Product Change Notice

JENSEN® JE5014

In order to ensure our products continue to evolve as the technological market changes, ASA Electronics will be updating the JENSEN® JE5014 television as follows:

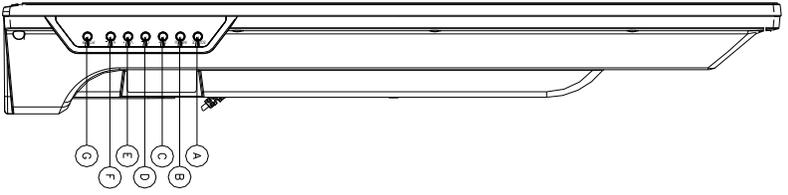
The JENSEN® JE5014 will be changing to a different IO configuration. The new Rev Level is denoted by "F" changing from the previous design of Rev Level "E". This change will be effective in September.

New Inputs:

- HDMI1 (ARC)
- HDMI2

Removed Inputs

- VGA
- 1/8" PC Audio
- HDMI3

- Please note there are no changes to the cabinet or mounting pattern.
